Licence Number L7815/2001/11

Licence Holder Saracen Metals Pty Ltd

Premises North Eastern Goldfields Operations

Amendment

Figure 2: Proposed modified Stage 6 General Arrangement Plan for TSF Expansion to the west to meet the Eastern Waste Dump (Knight Piesold 2017c).

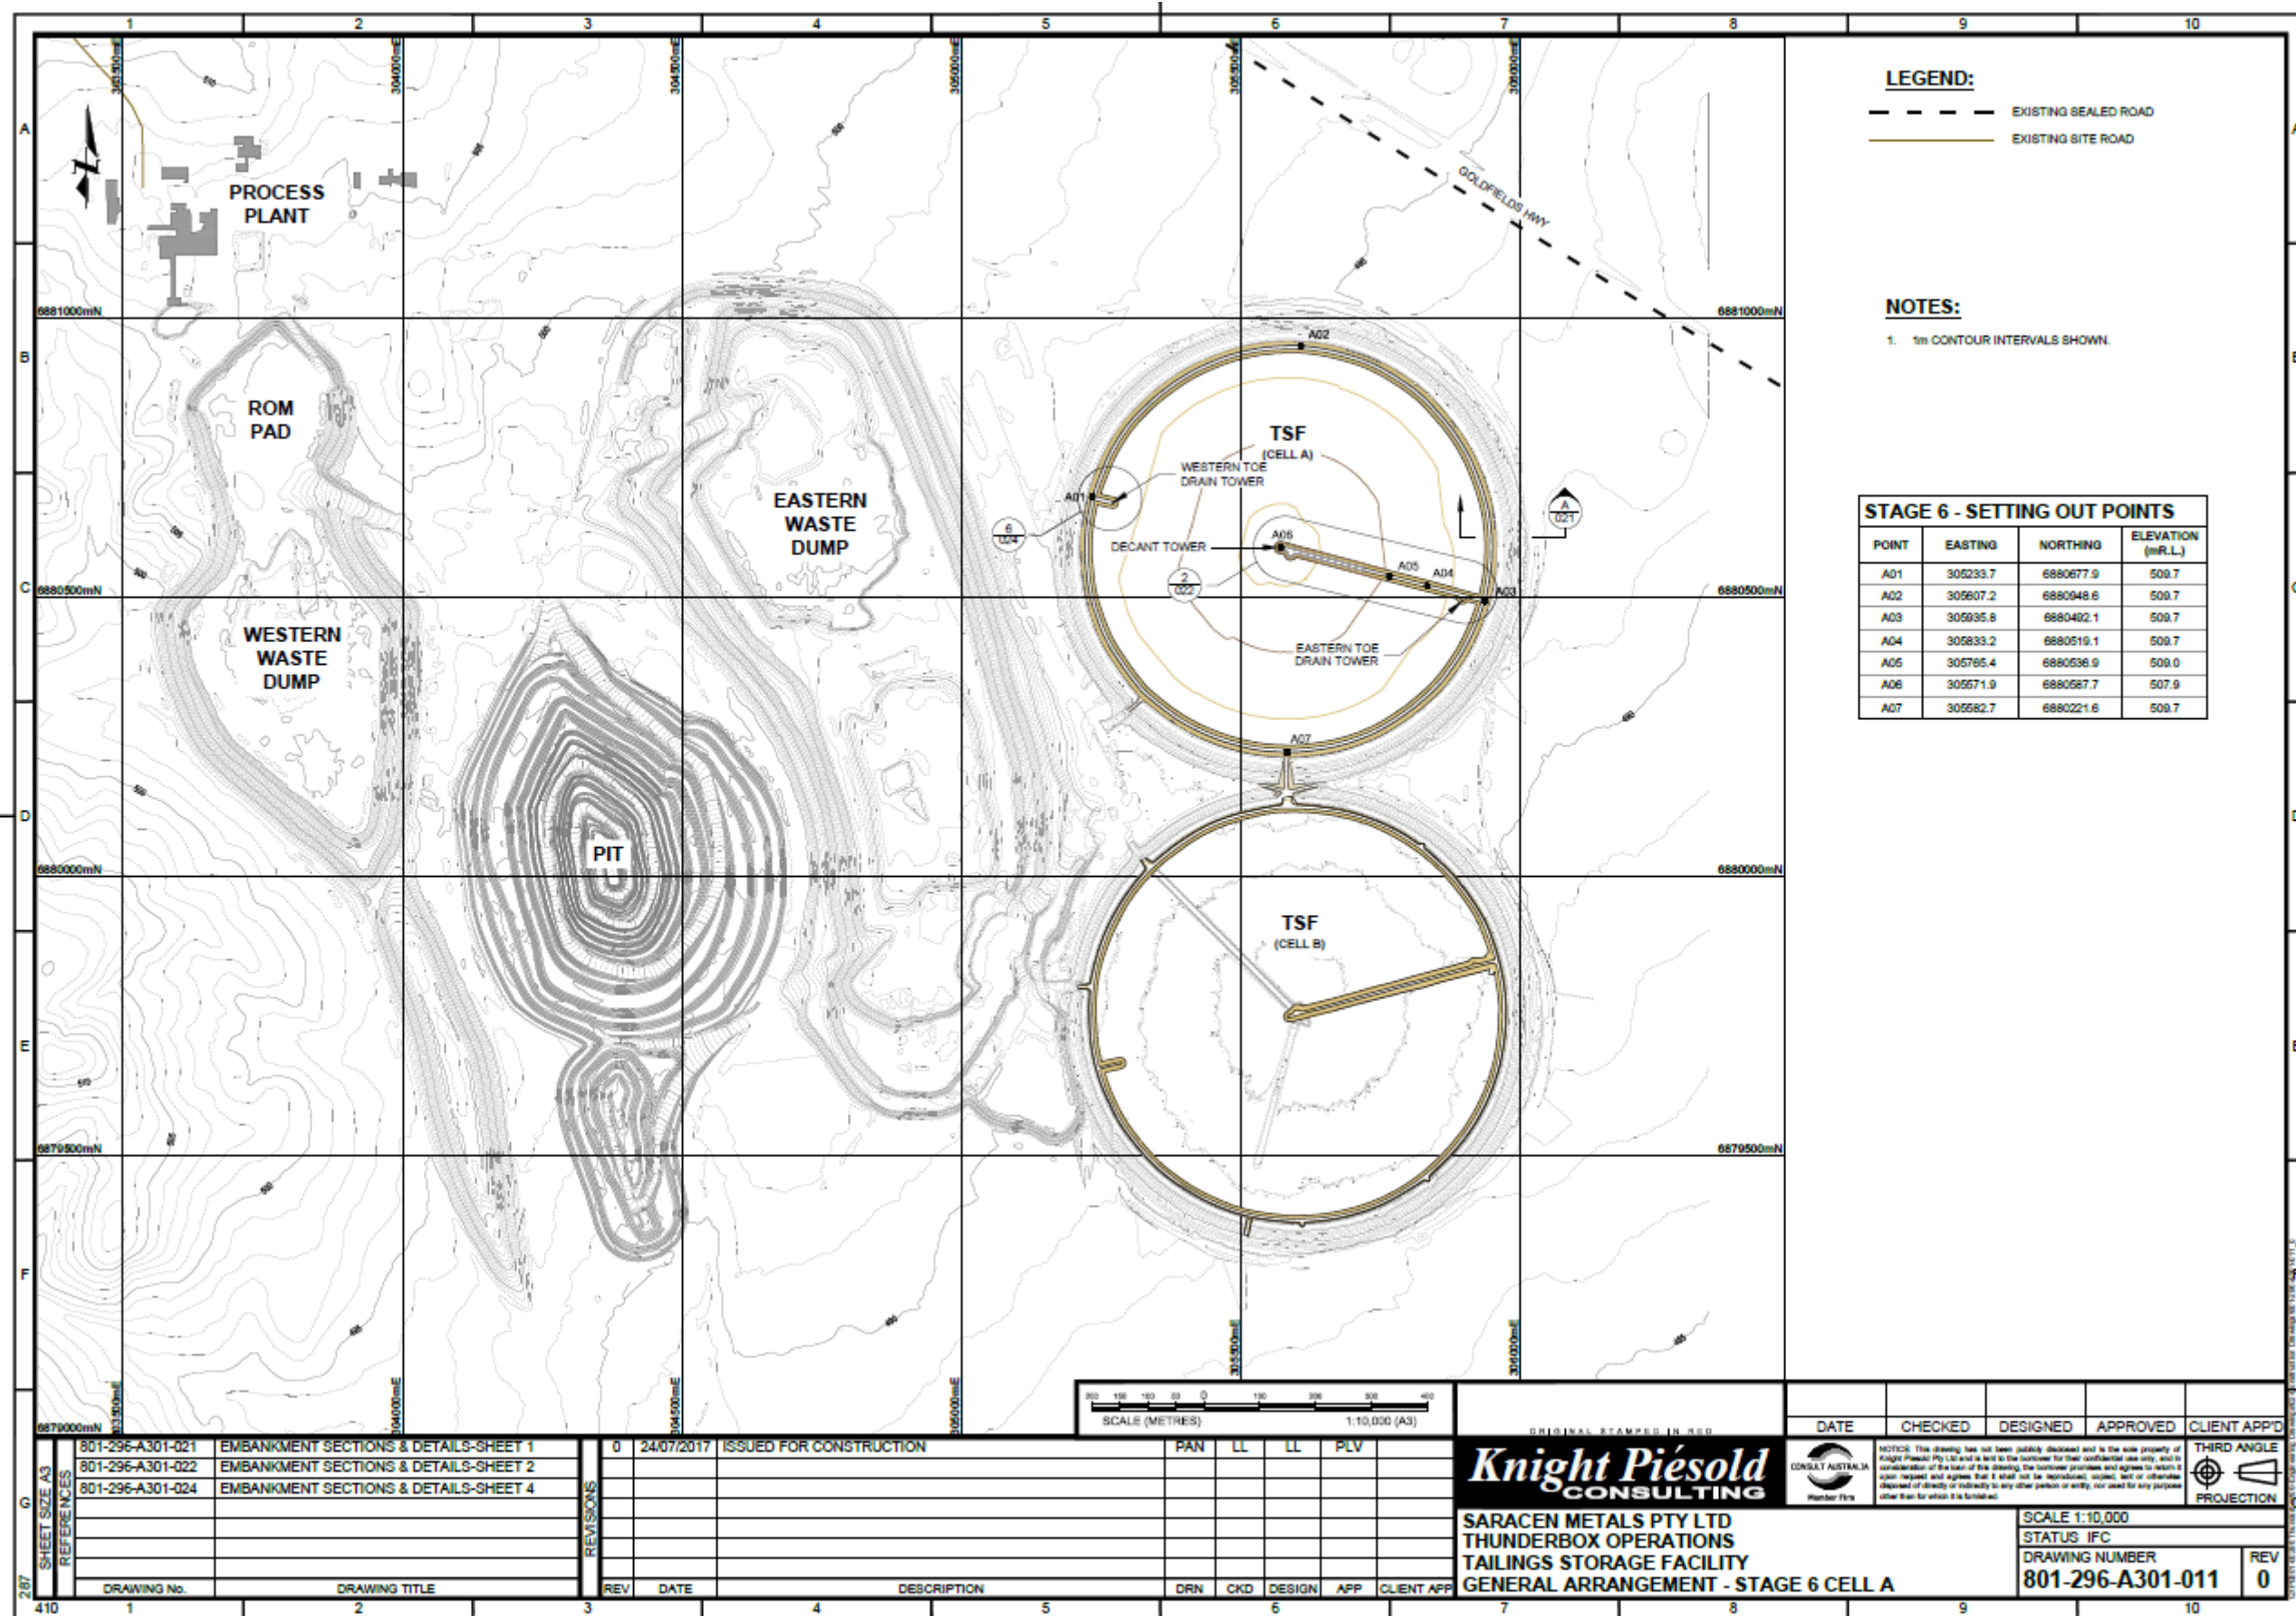
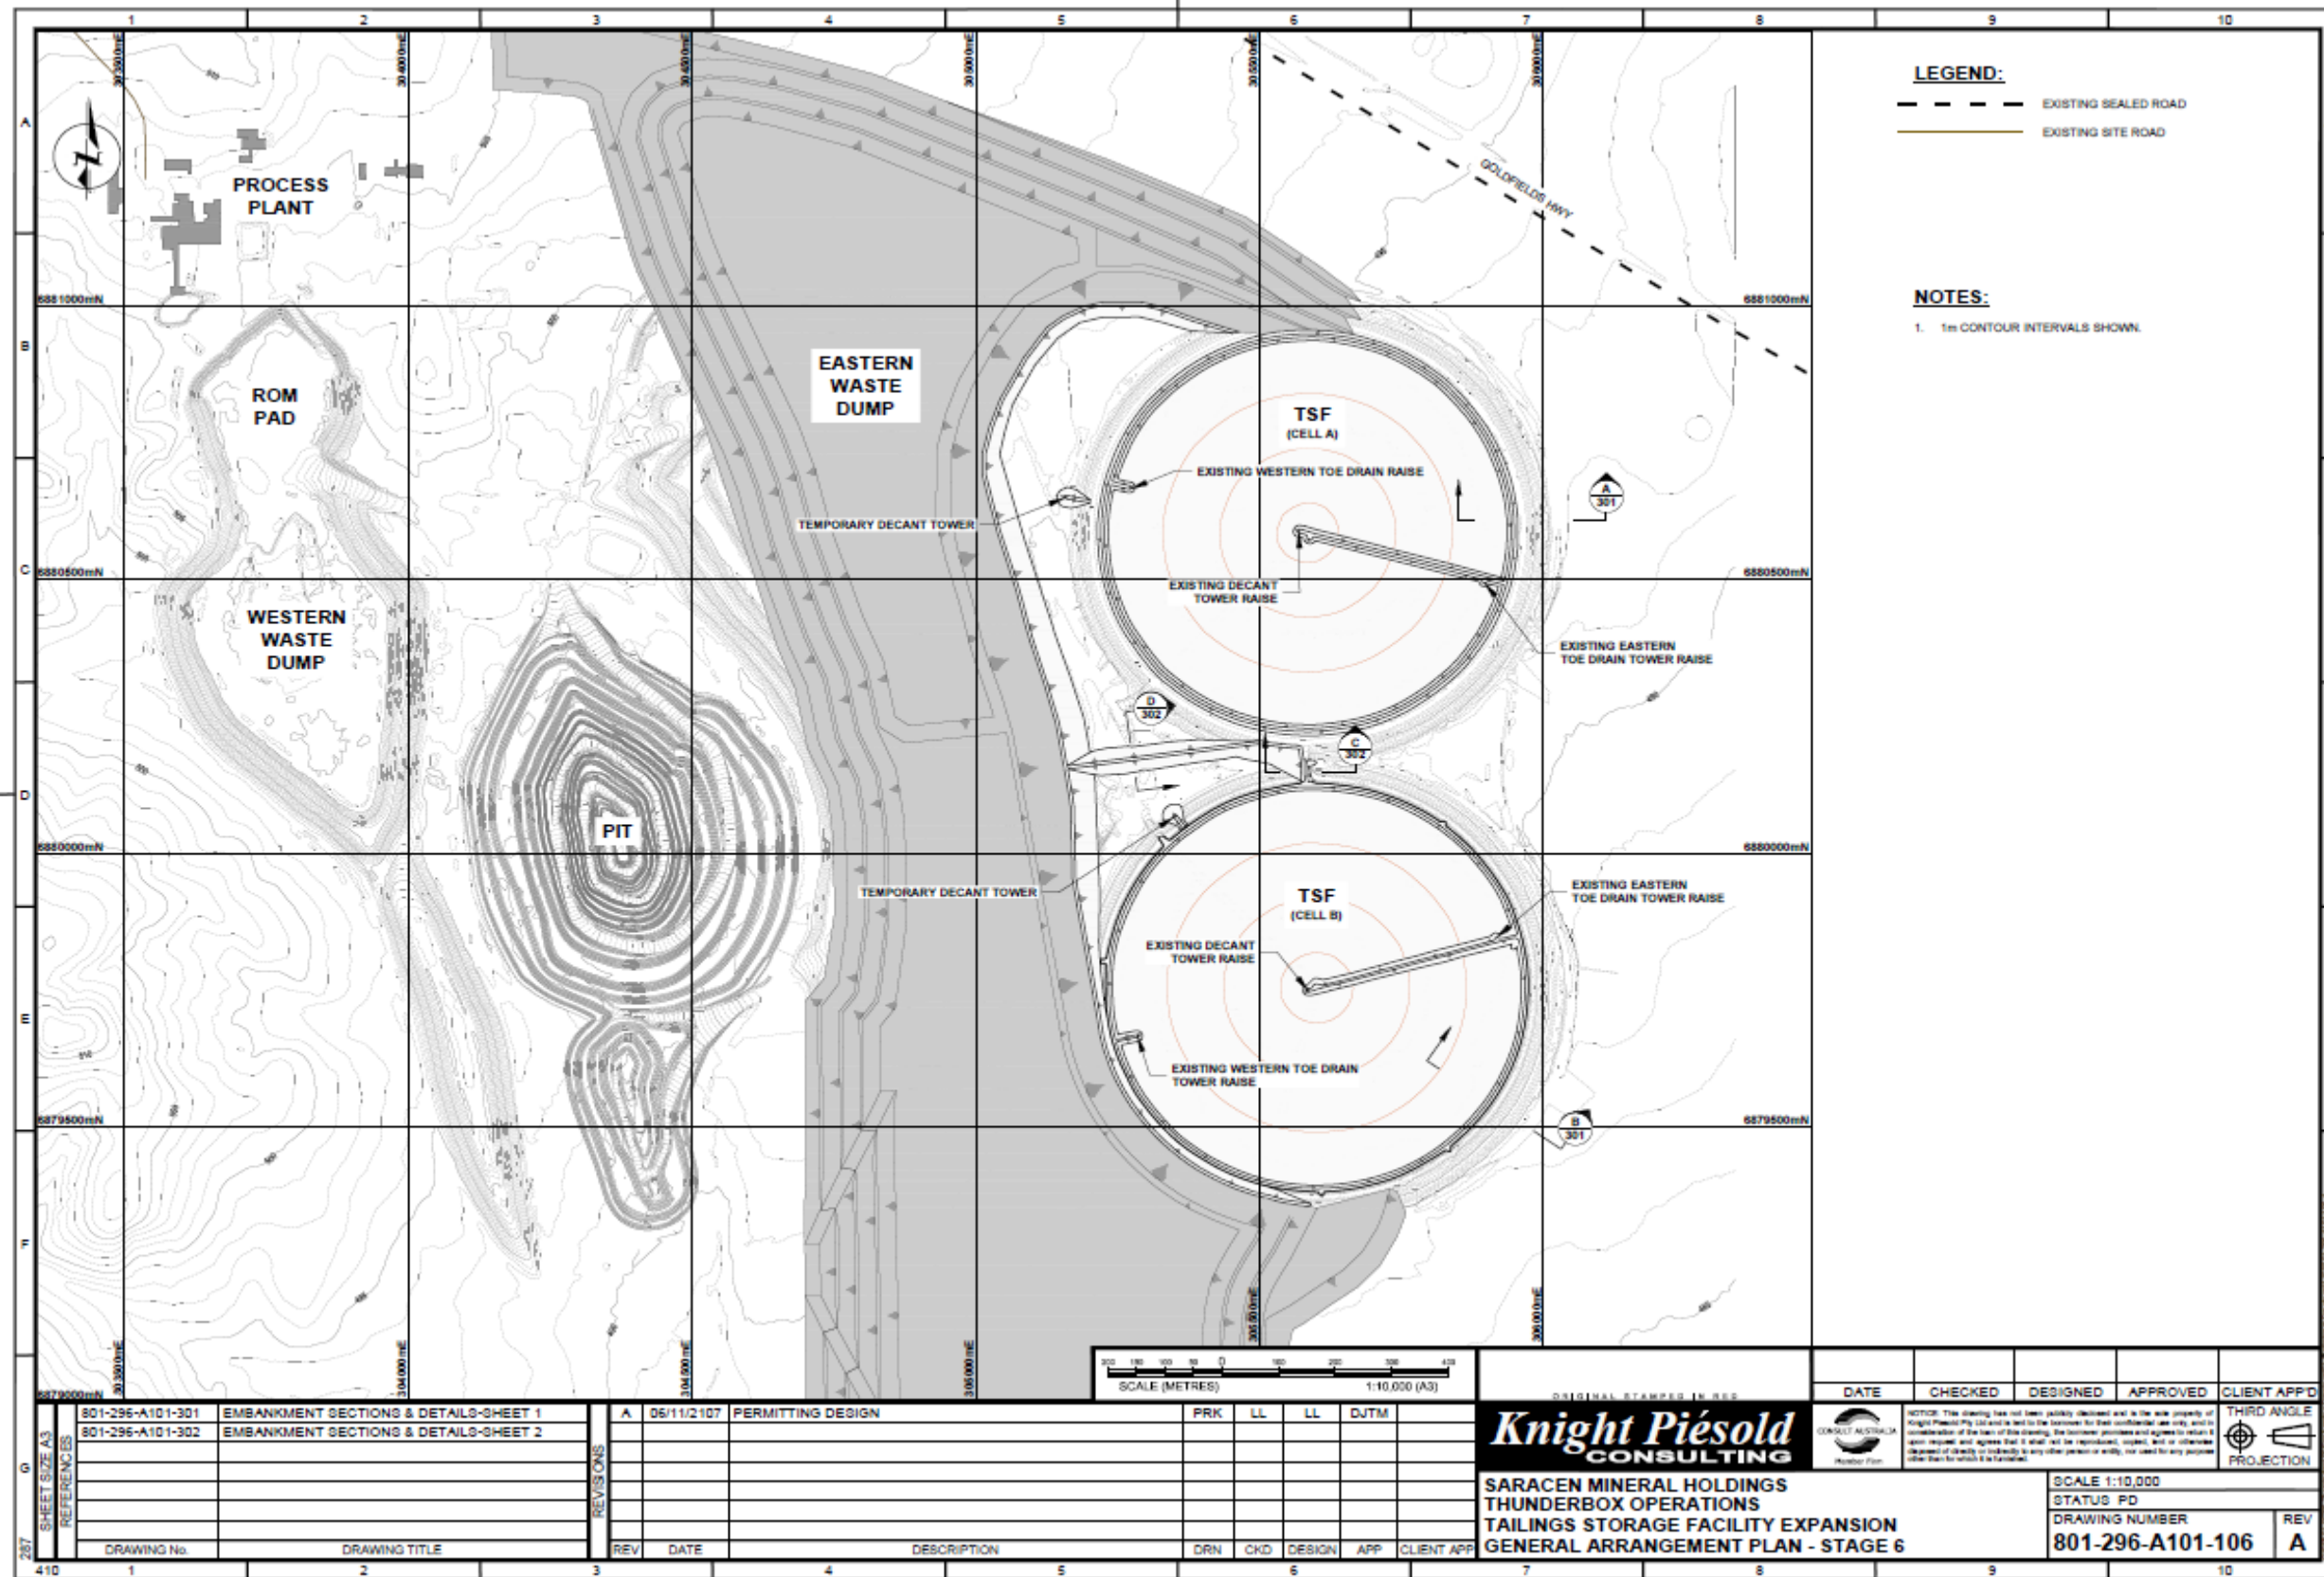
DWER received an application to amend Licence L7815/2001/11 to construct a modified design for the tailings storage facility (TSF) Cells A and B in order to utilise additional surface area between the existing Cells A and B and the adjacent Eastern Waste Dump.

<u>Stage 6 TSF modified Cell A and Cell B design</u>	<ul style="list-style-type: none"> <u>Install a 300mm compacted soil liner over the expansion area as shown in Knight Piesold (2017c) drawing 801-296-A101-106 with a hydraulic conductivity of at least 1×10^{-8} m/s.</u> <u>Install underdrainage collection system within the expansion area as per Knight Piesold (2017c) drawings 801-296-A101-406, 801-296-A101-551 and 801-296-A101-552.</u> 	<p><u>Expansion area as shown in Figure 2 of this Amendment Notice 2.</u></p> <p><u>TSF expansion underdrainage details and location as shown in Figure 3 – 5 of this Amendment Notice 2.</u></p>
<u>Groundwater monitoring bores</u>	<ul style="list-style-type: none"> <u>Installation of nested bores at MB7S (slotted at shallow depth 1mbgl – 5mbgl) MB7D (slotted to encounter groundwater) and MB8S (slotted at shallow depth 1mbgl – 5mbgl) and MB8D (slotted to encounter groundwater) at locations as shown in Knight Piesold (2017c) drawing 801-296-A101-900 (also referred to as Figure 4b in this amendment).</u> 	<u>Monitoring Bores Location as per Figure 4b of Schedule 1.</u>
